REGULATORY INFORMATION DISTRIBUTION SYSTEM (RIDS)

SUBJECT: Forwards responses re main steam line break reanalysis,per
880301 commitment.

Subject: Palo Verde Nuclear Generating Station (PVNGS)
Units 1, 2 and 3
ANPP Responses to NRC Main Steam Line Break Questions
File: 88-A-056-026

ANPP RESPONSES TO NRC MAIN STEAM LINE
BREAK QUESTIONS

FIGURE 6
RCS PRESSURE

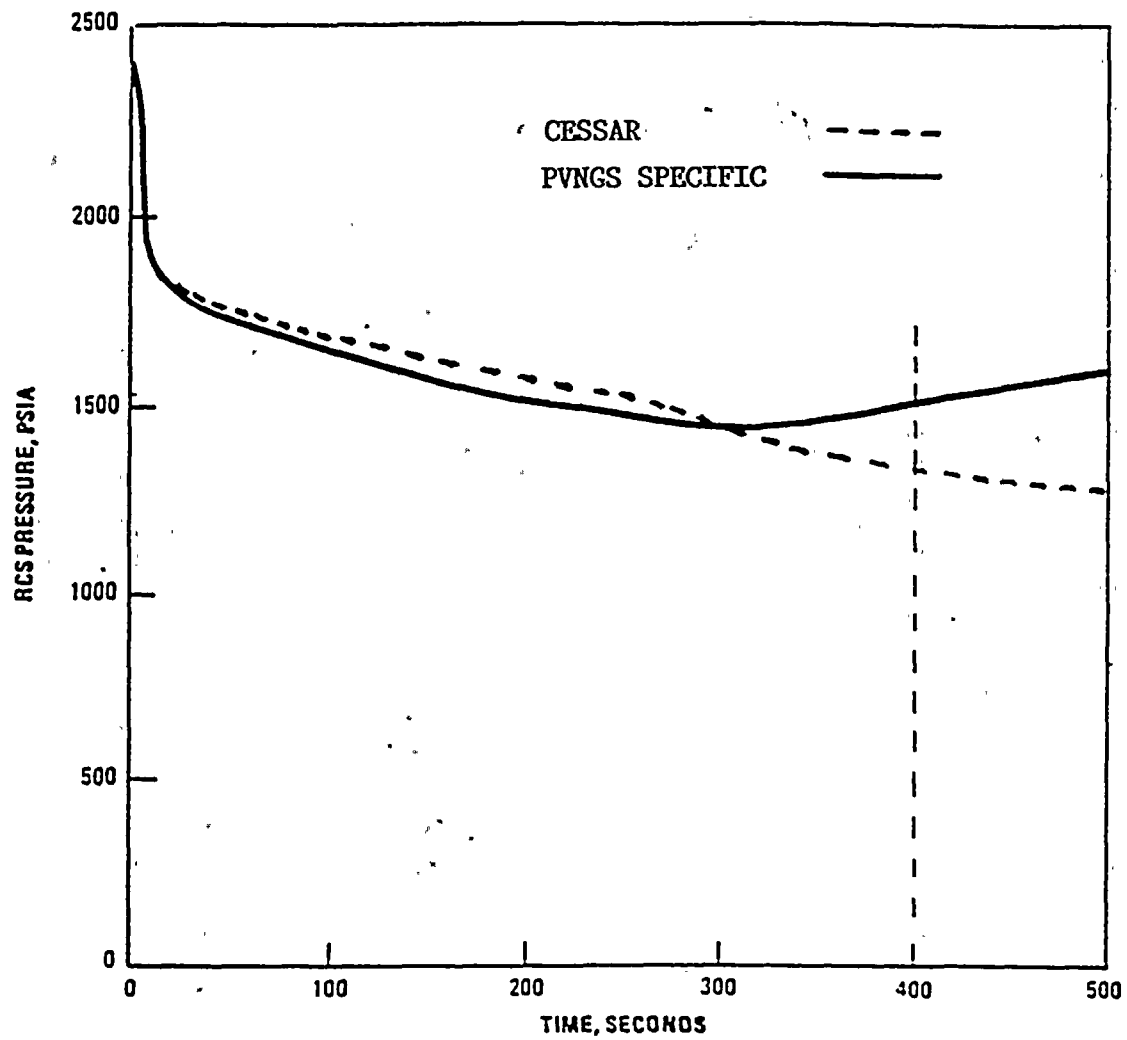
The licensee, in lieu of using a non-equilibrium upper head model (which would produce higher upper head pressures thus limiting boron injection) has modified the CESEC code to artificially shift steam created in the upper head to the pressurizer. Describe in depth how this methodology differs from that used in CESEC-III and its impact on the resultant pressure computation.

As the refill proceeds, the total steam volume in the RCS (i.e., pressurizer plus RVUH) is compressed utilizing the non-equilibrium pressurizer model and a more realistic pressure transient is predicted during this time as shown in Figure 6.

The important factor during the refill part of the SLB event simulation is the impact of the modeling on the RCS pressure, which directly governs the amount of the safety injection fluid entering the system. Utilization of the pressurizer model to determine both of these parameters yielded higher RCS pressures and lower safety injection flow rates (Figure 7), consequently increasing a potential for post-trip return to power, and therefore, produced more conservative results than the previous CESEC model. Although it is difficult to quantify separate effects, at the time of the peak reactivity, the modified version predicts core reactivity to be more positive by approximately $0.1\% \Delta \rho$.

FIGURE 7 SAFETY INJECTION FLOW

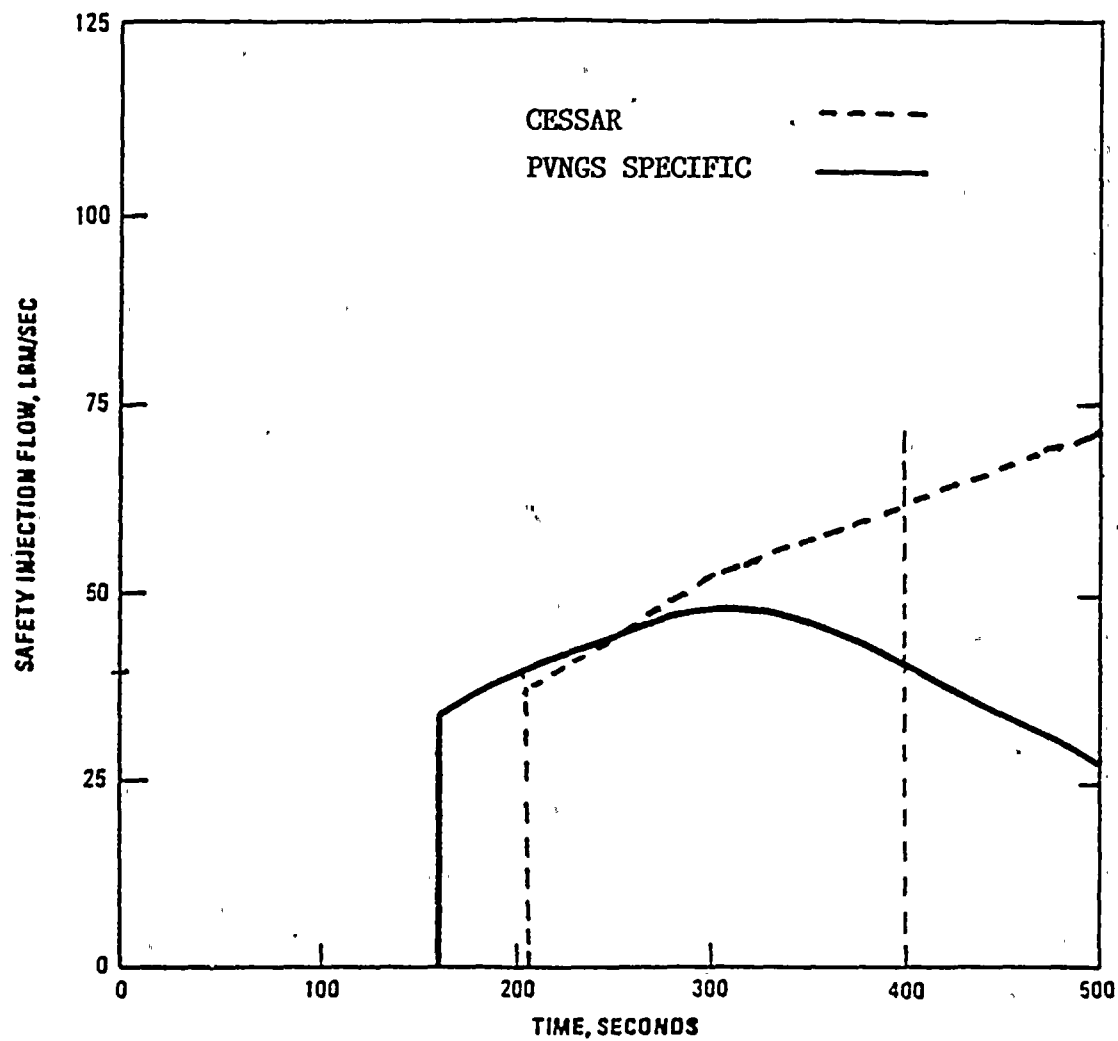
Examination of the changes in Figures 15.1.1.7 indicates a reduction in the negative reactivity insertion accompanying safety injection at a rate causing a change of slope of roughly 1/3. However, changes in Figure 15.1.1.15 indicate that the safety injection flowrate, although varying, is roughly 50% lower in the new computation at, for example, 400 seconds than it was in the original computation, indicating that the new computation may use a higher boron concentration. Explain this result and its connection with the boron transport model changes discussed in Question 2.

The safety injection flow rate decreased by roughly 1/3 (not 1/2 as stated in the question) at 400 seconds compared to the previous analysis (Figure 7). This decrease in the safety injection flow rate is due to the combination of the reduced HPSI delivery curve (required by Technical Specifications for the minimum HPSI ECCS performance) and higher RCS pressure (Figure 6) as explained in response to Question #3.
